CITY PLAN COMMISSION STAFF REPORT

Gracehaven Subdivision

CD-CPC-2025-00028

CD-CPC-2025-00030

sheet
C3.0
Civil
SITE PLAN
permit
10 FEBRUARY 2025

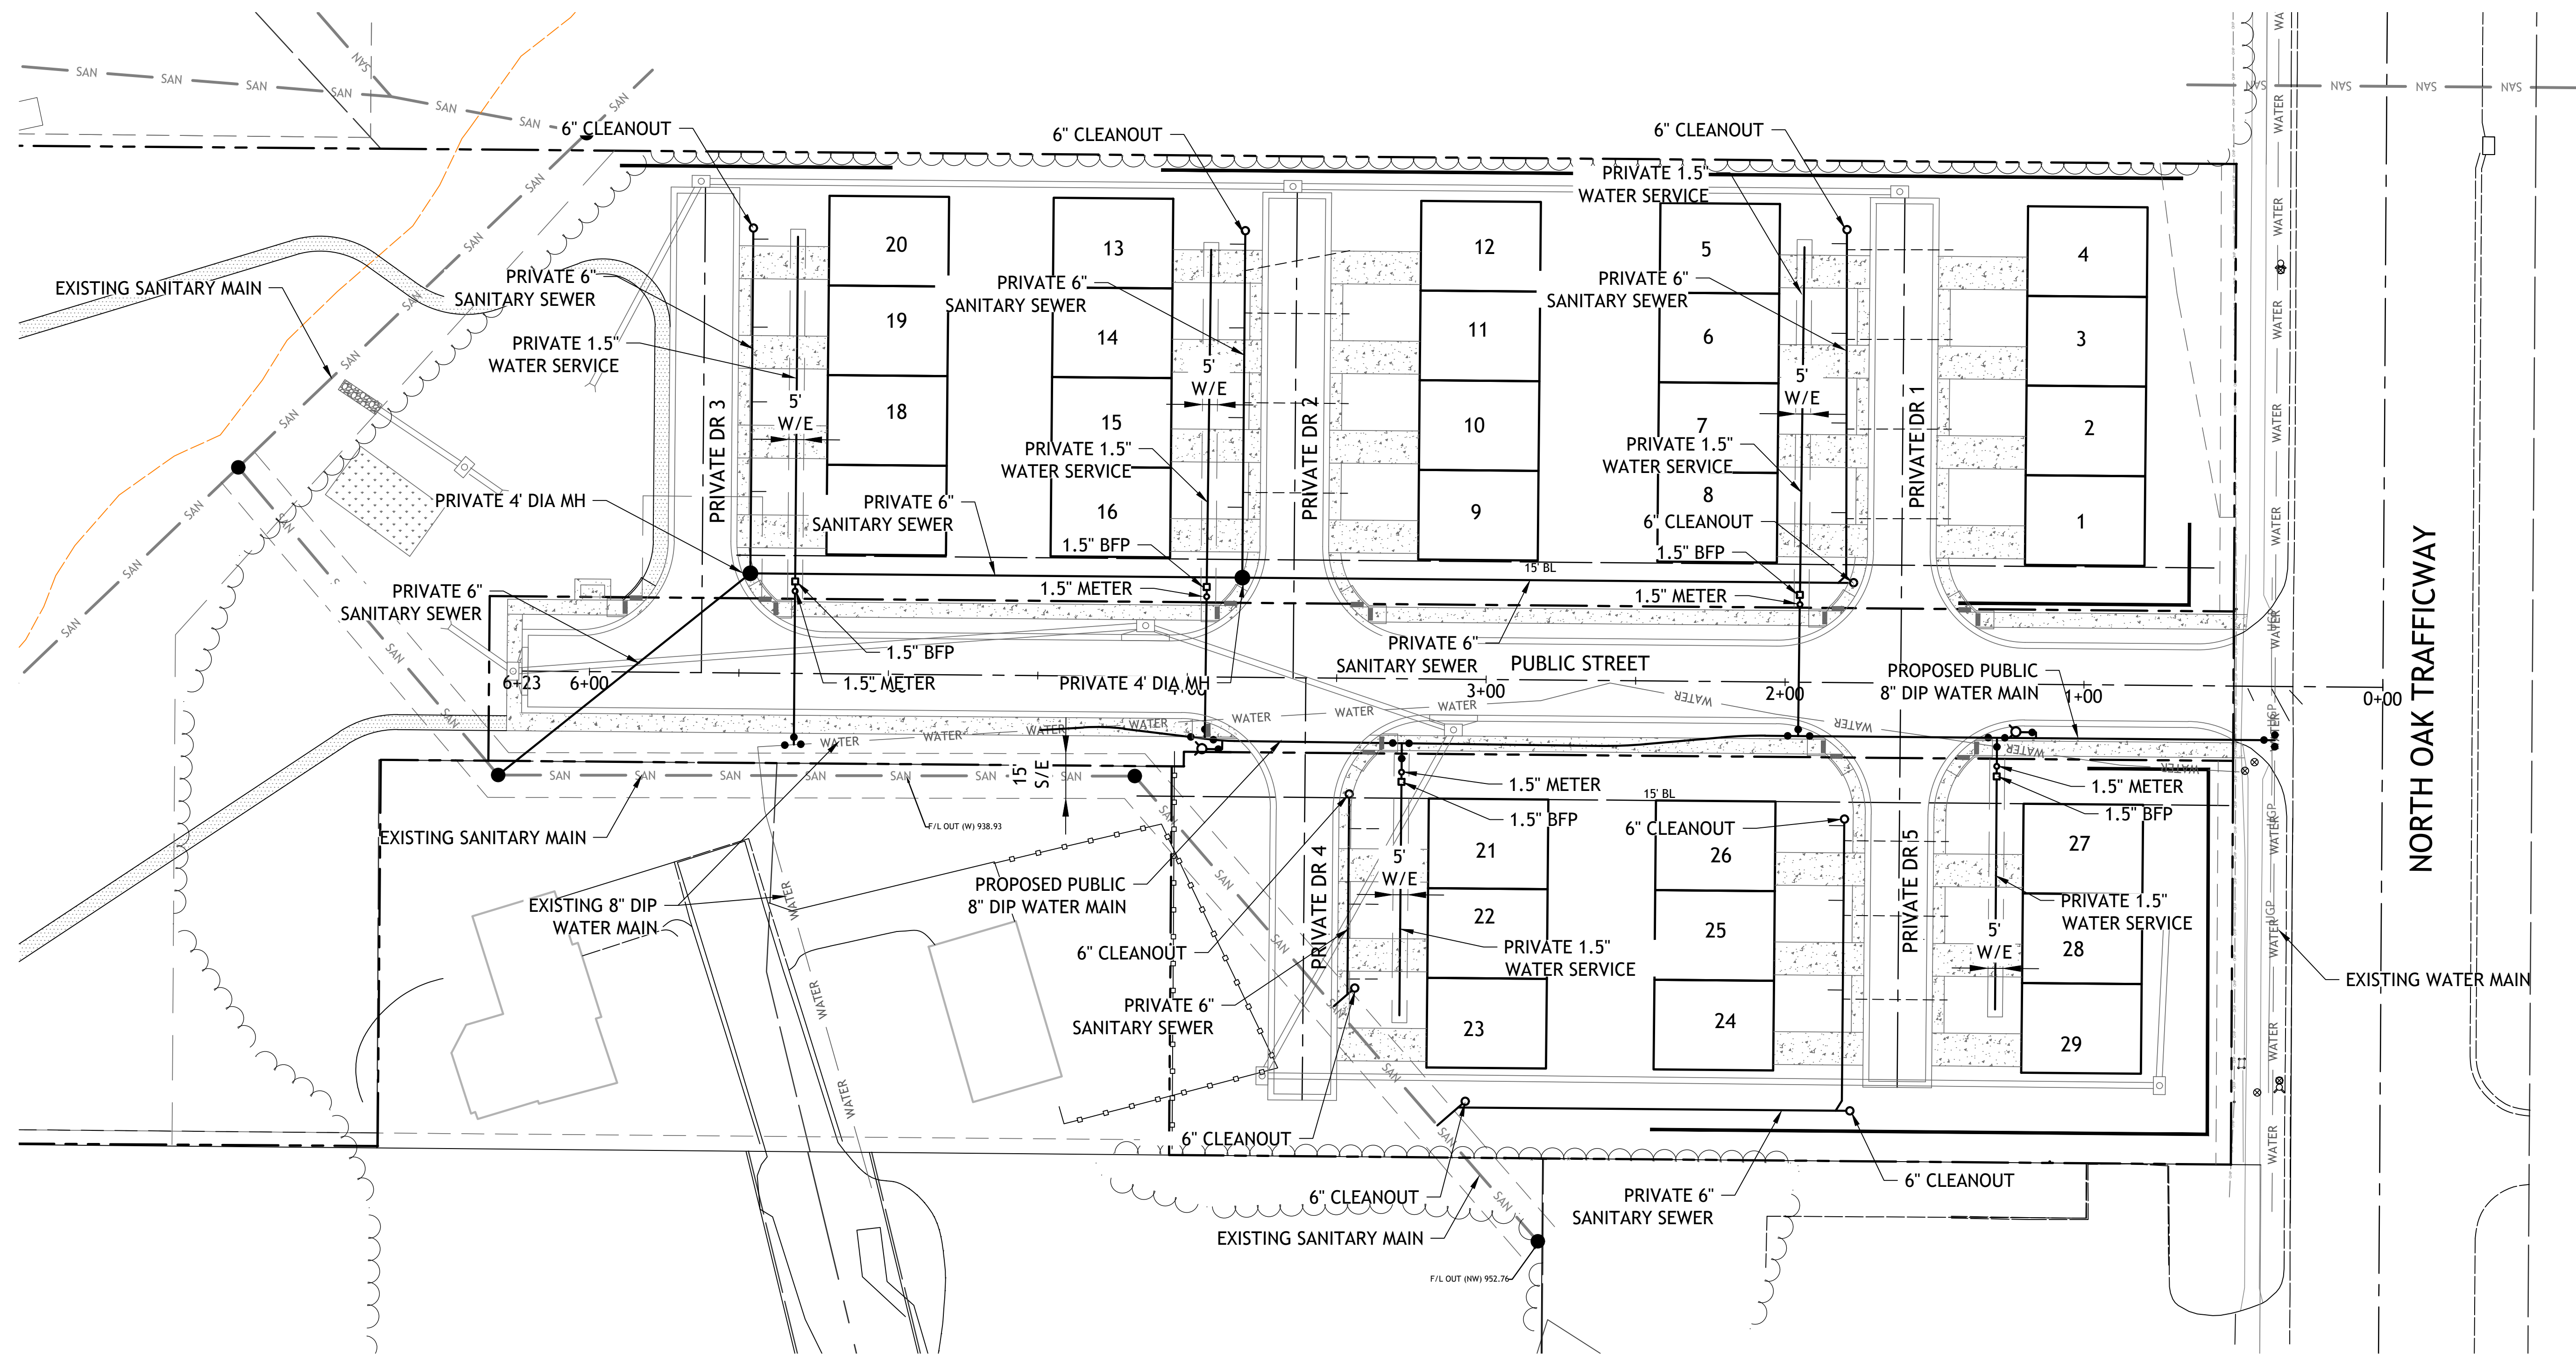
20. The Parks and Recreation Department is not supportive of the use of Tract A as Private Open Space to satisfy the Parkland Dedication requirements as it also includes areas for stormwater management. The plans shall be revised to exclude Tract A as Private Open Space and only include the proposed trail if constructed to Parks standards prior to City Council determination.

PROPOSED PARK LAND DEDICATED
REQUIRED 29 UNITS X 2 = 58 X 0.006 = 0.34ac

PROPOSED 1.84ac

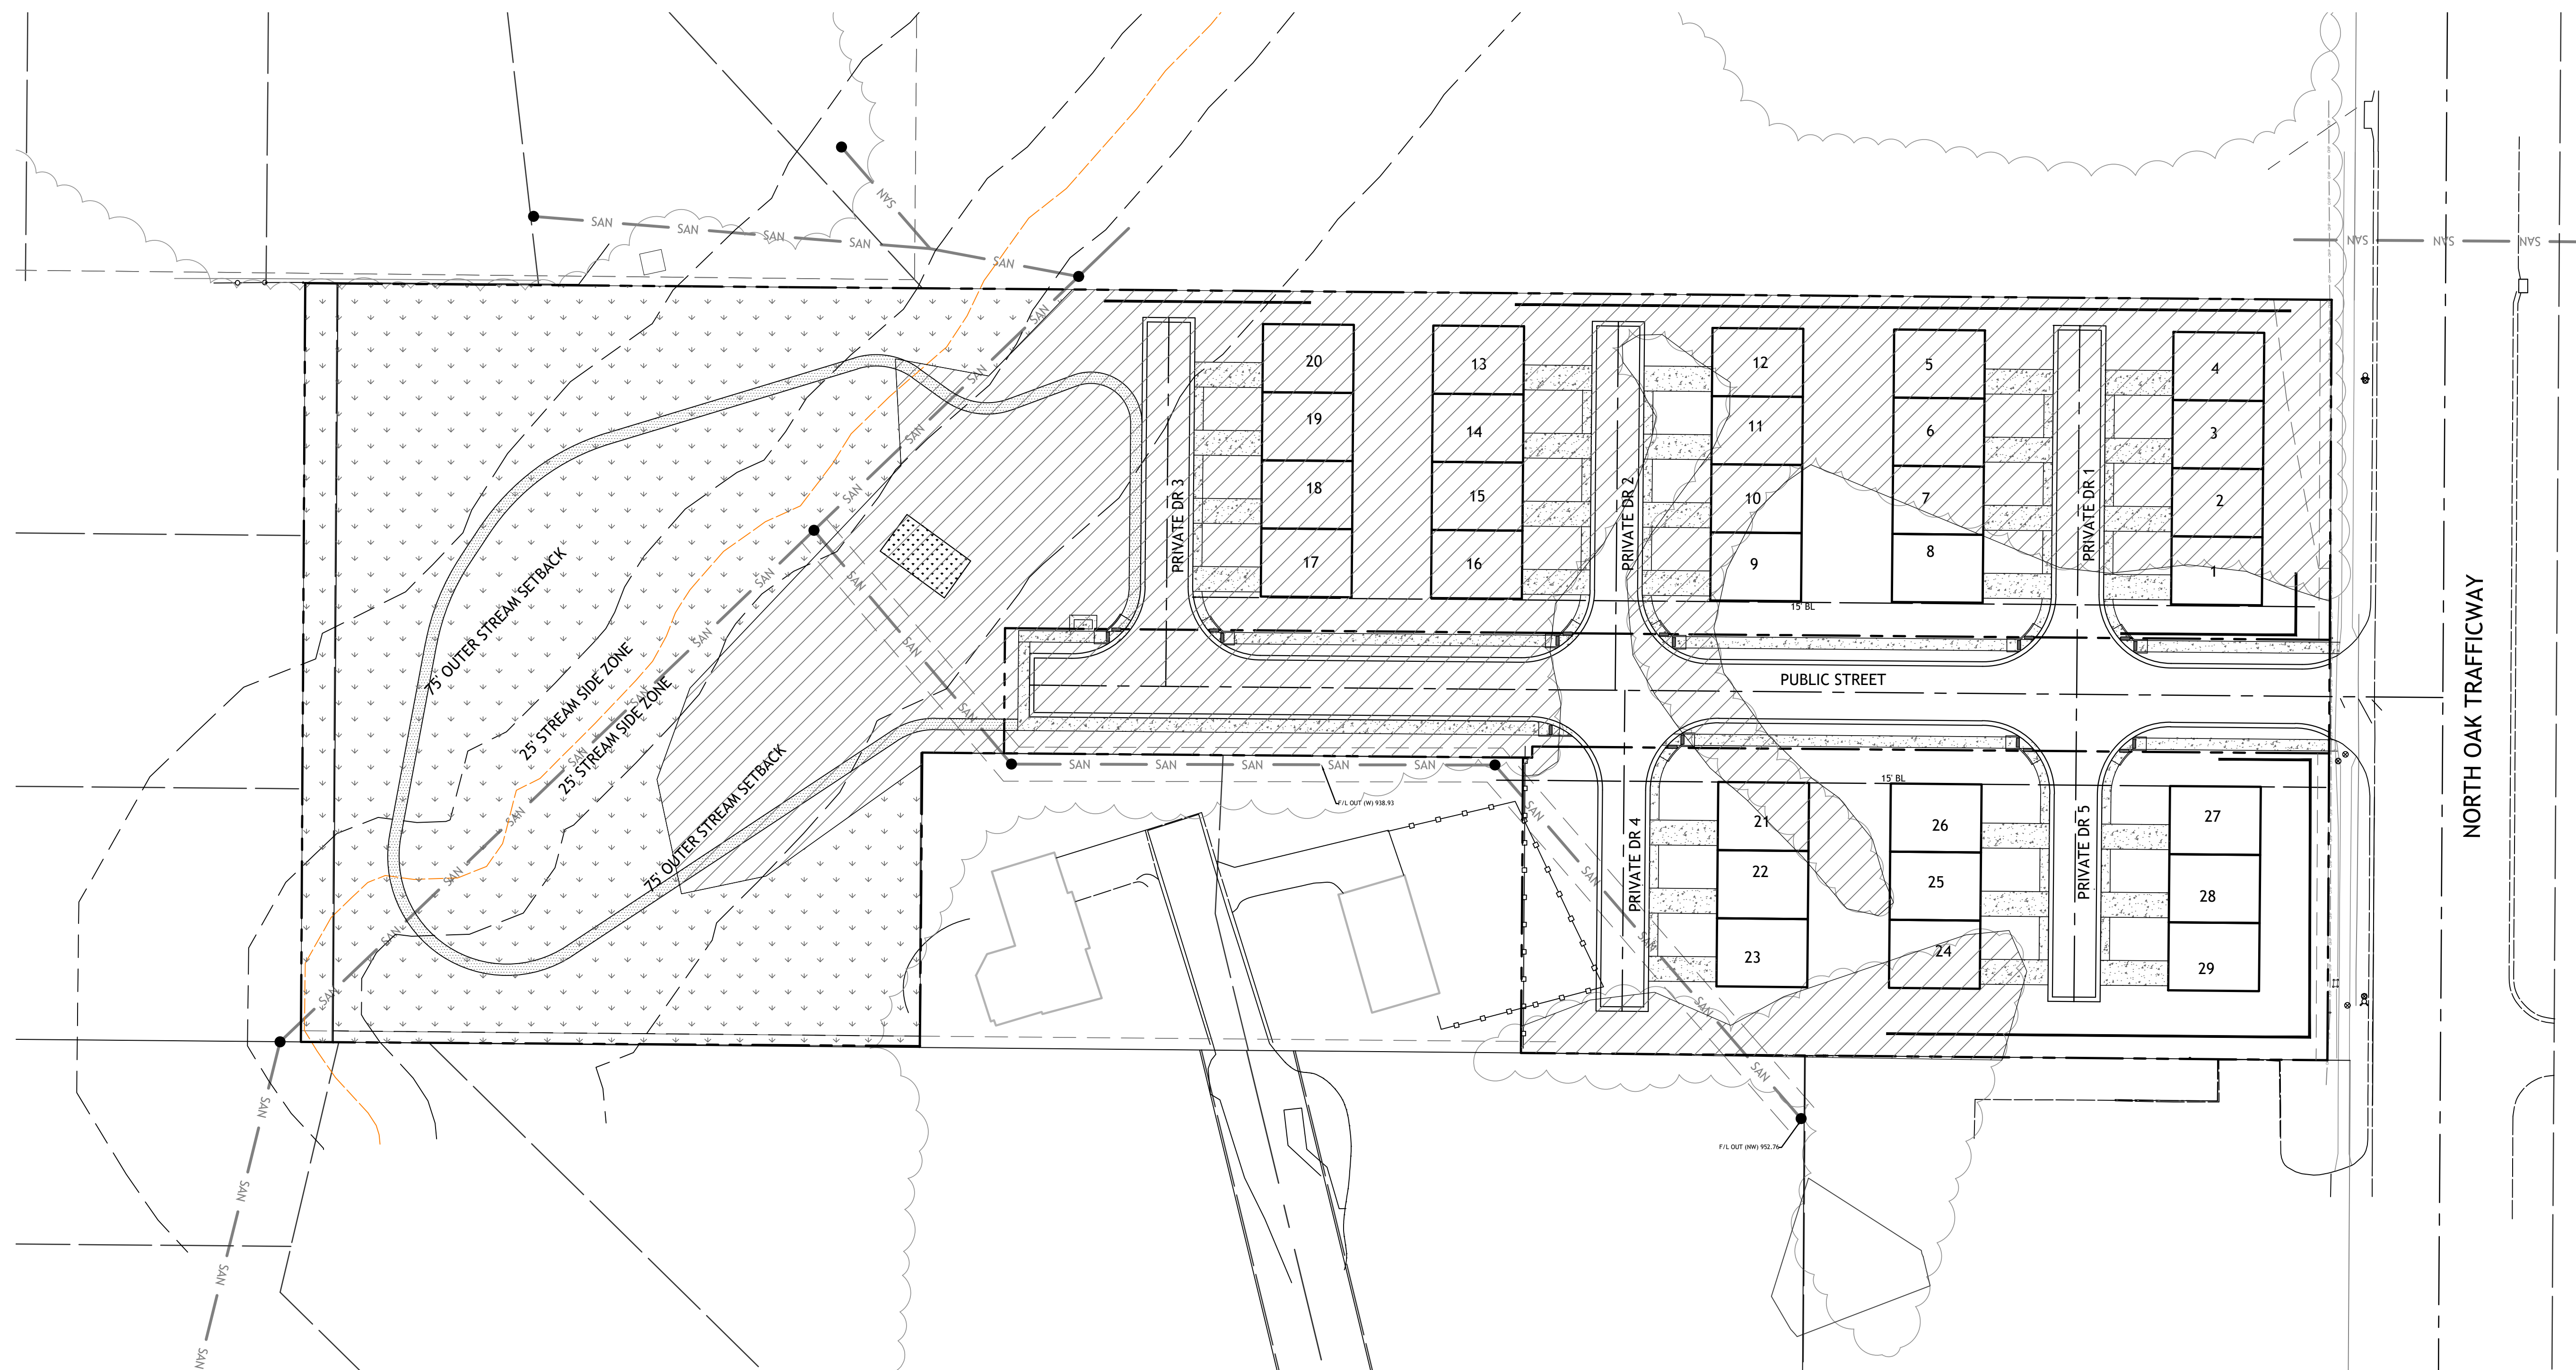
The plans identify two and a half acres of tree canopy will be removed for the proposed development. Just under two acres of tree canopy will be preserved around the stream corridor on the western half of the site. Due to the amount of preservation and landscaping proposed, no mitigation is required.

NOTE: NO MITIGATION IS REQUIRED ON CALCULATIONS

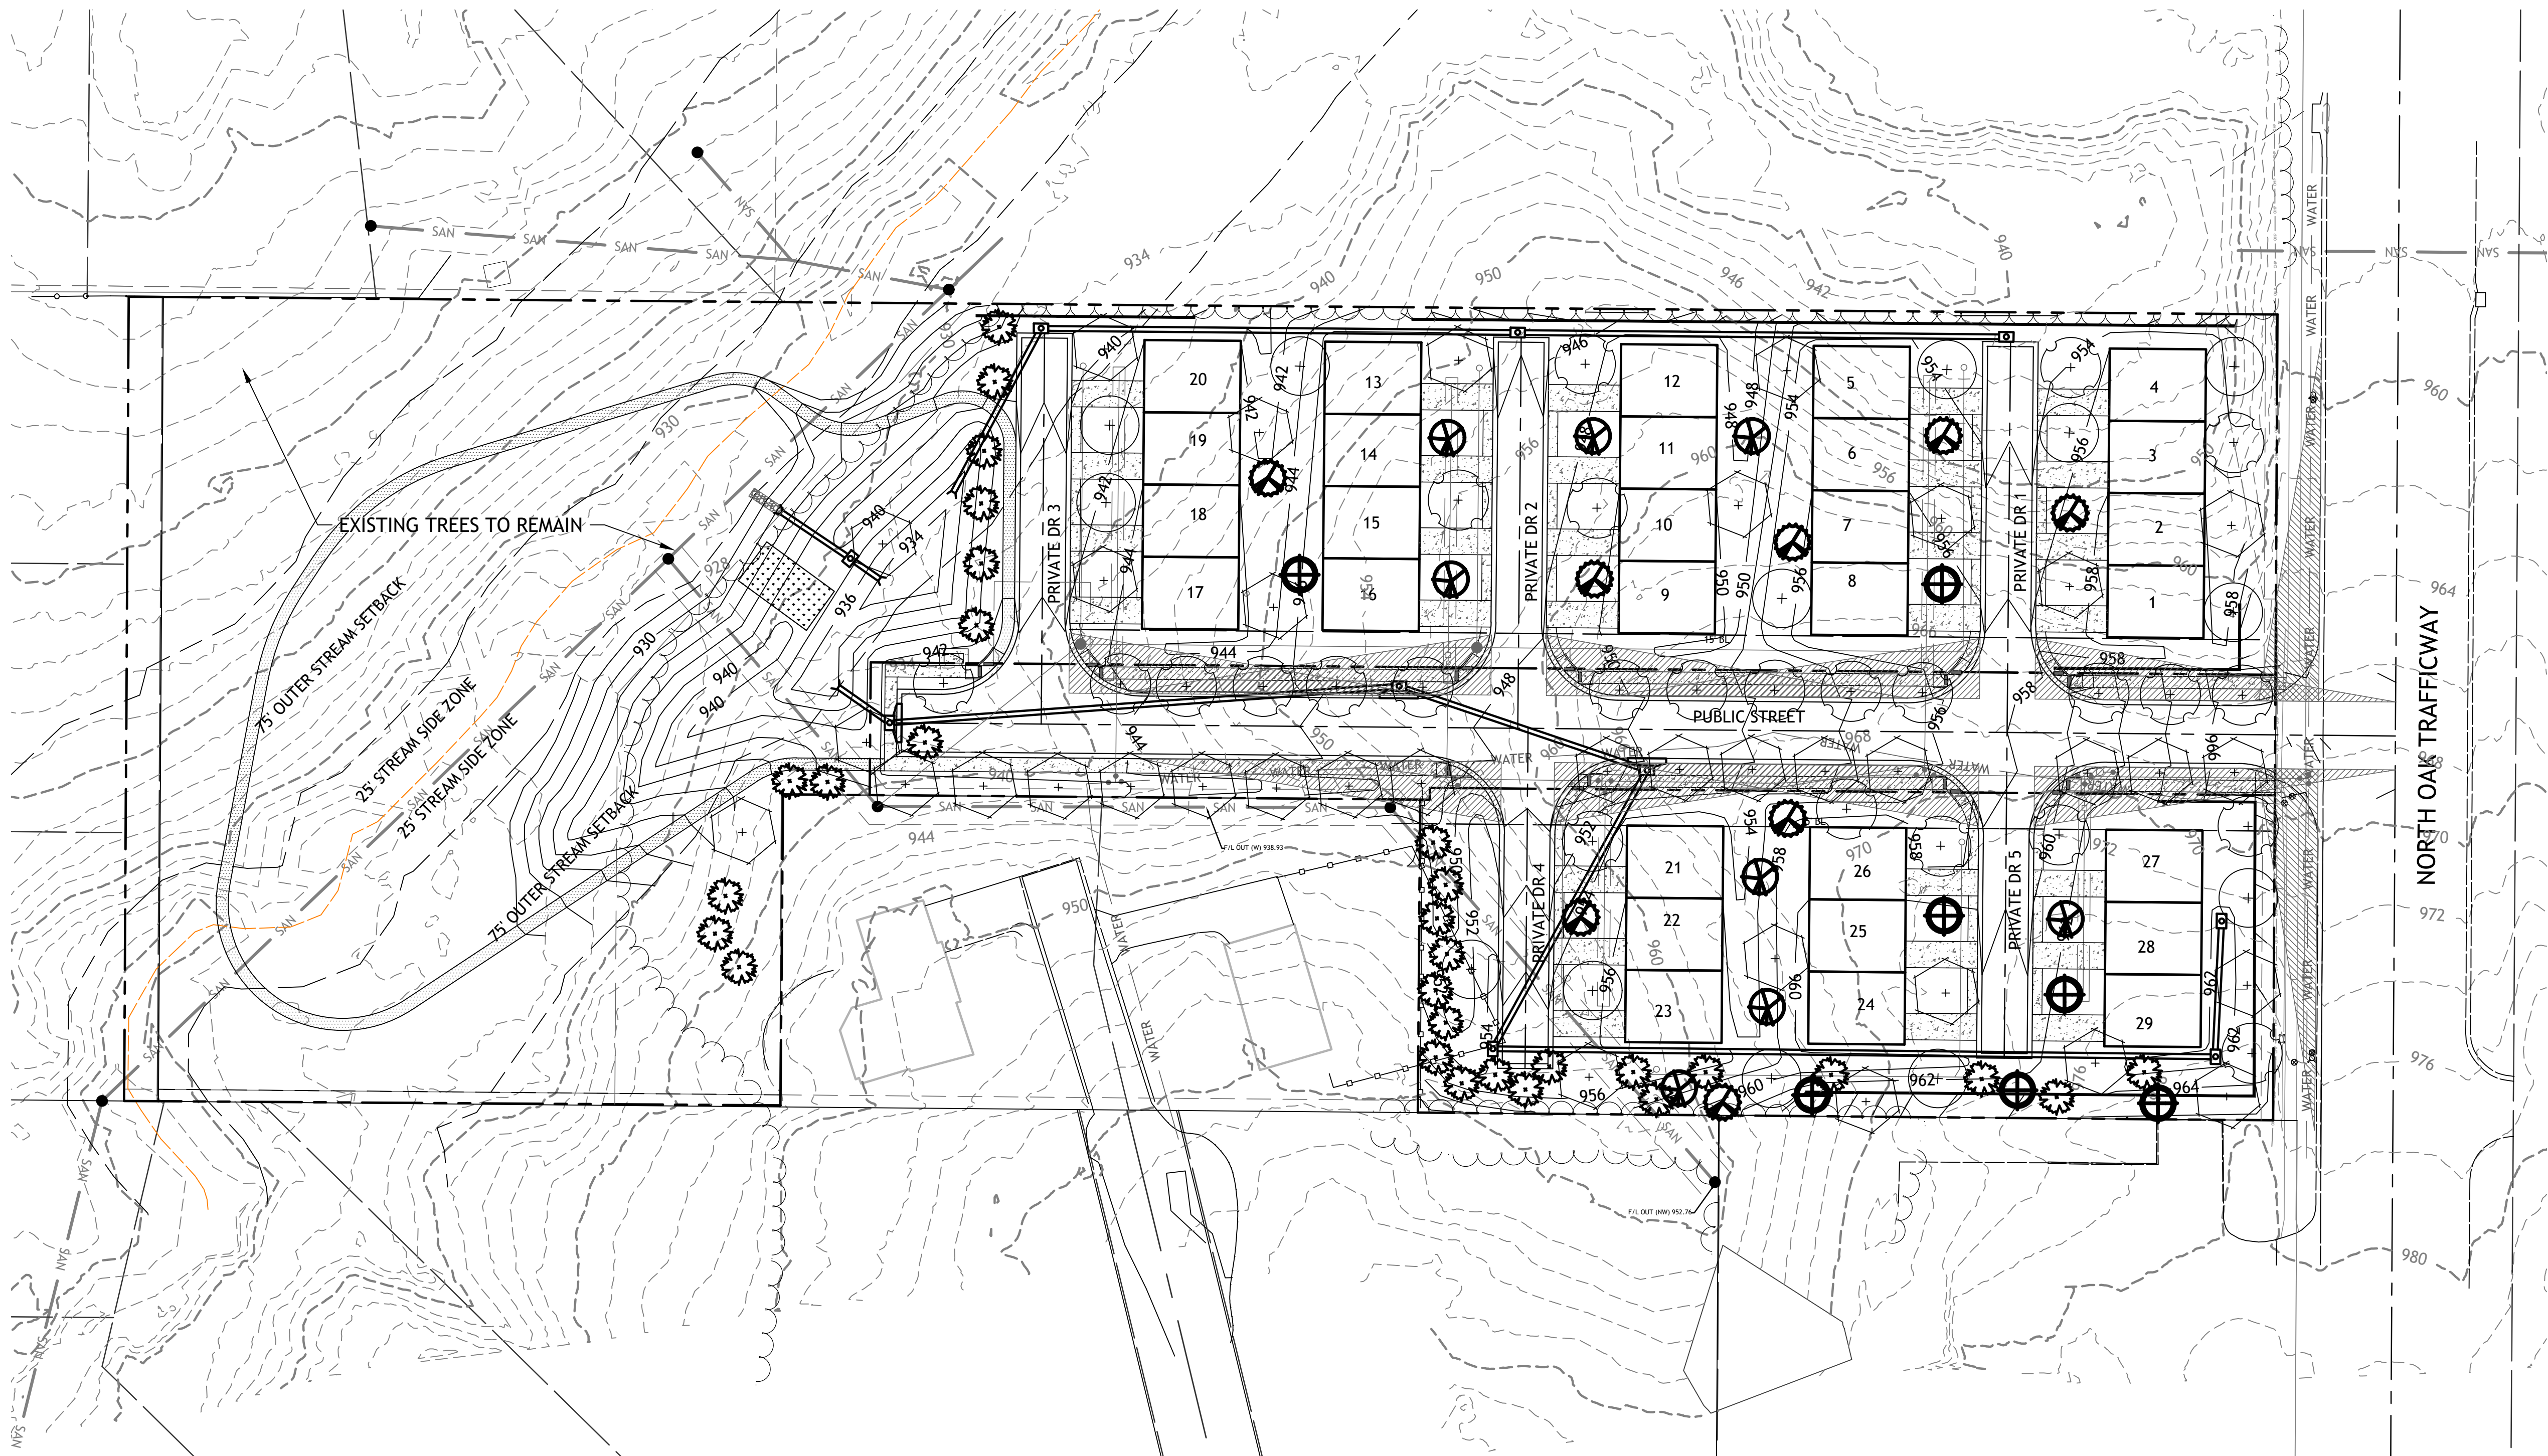
Long Range Planning reviewed and determined "This project advances some goals outlined in the Gashland/Nashua Area Plan and KC Spirit Playbook. The development plan matches the future land use on the site and provides appropriate transitions from N Oak. Applicant has added sidewalks throughout the site for connectivity. Additional landscaping was requested as N Oak is designated as a primary image street, however due to site triangles this request was not able to be met." -Alexis Berra

NOTE:
CITY REQUIRED STREET TREES IN SITE
TRIANGLE ON INTERNAL PUBLIC STREET
